Access Compliance Report

Public Rights-of-Way

Intersection ID: 10759	Main Street: SPRATT_ST	Cross Street: OLIVER_ST	Location: NE
ADA ID: 5C4F36E2AFDF	Ramp Type: Perp	Initial Pass/Fail: Fail	Overall Compliance: No
		Severity Score: 10

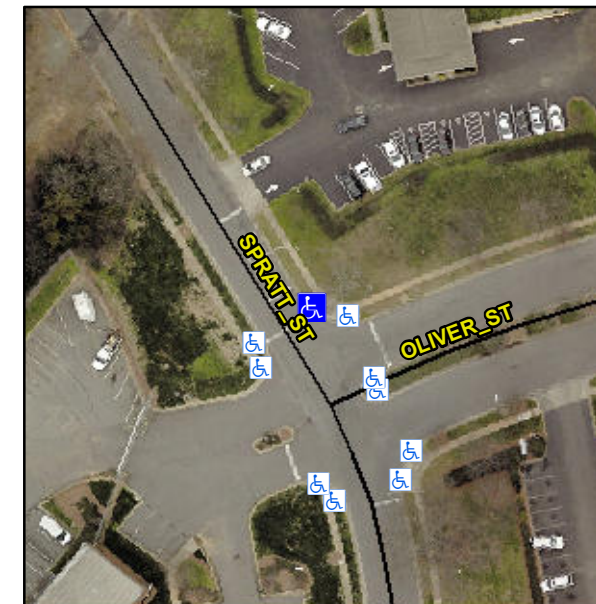
Not Found, R304.5.1, R304.5.3

Compliance	Description	Data	Compliance	Description	Data
N/A	Ramp Length (in)	114.5	Yes	Ramp Slope (%)	5.2
No	Ramp Width (in)	43.5	No	Ramp XSlope (%)	2.9
N/A	Flare Type LT	N/A	N/A	Flare Type RT	N/A
N/A	Flare Slope LT (%)	N/A	N/A	Flare Slope RT (%)	N/A
N/A	Flare Traversable LT?	N/A	N/A	Flare Traversable RT?	N/A
N/A	Landing Length (in)	N/A	N/A	DWS Provided?	N/A
N/A	Landing Width (in)	N/A	N/A	DWS Contrast?	N/A
N/A	Landing Slope (%)	N/A	N/A	DWS Length (in)	N/A
N/A	Landing X Slope (%)	N/A	N/A	DWS Full Width?	N/A
N/A	Landing Curb? (Y/N)	N/A	N/A	DWS Offset (in)	N/A
N/A	Shared Landing?	N/A			
N/A	Gutter Ponding?	N/A	N/A	Gutter Slope (%)	N/A
N/A	Gutter Lip Ht (in)	1.0	N/A	Gutter X Slope (%)	N/A
N/A	Painted X Walk1?	No	N/A	Painted X Walk2?	N/A
	X Walk 1 Direction	To SW		X Walk 2 Direction	N/A
N/A	X Walk 1 Width (in)	N/A	N/A	X Walk 2 Width (in)	N/A
	X Walk 1 Slope (%)	4.1		X Walk 2 Slope (%)	N/A
	X Walk 1 X Slope (%)	1.4		X Walk 2 X Slope (%)	N/A

Remove & Replace Entire Ramp.
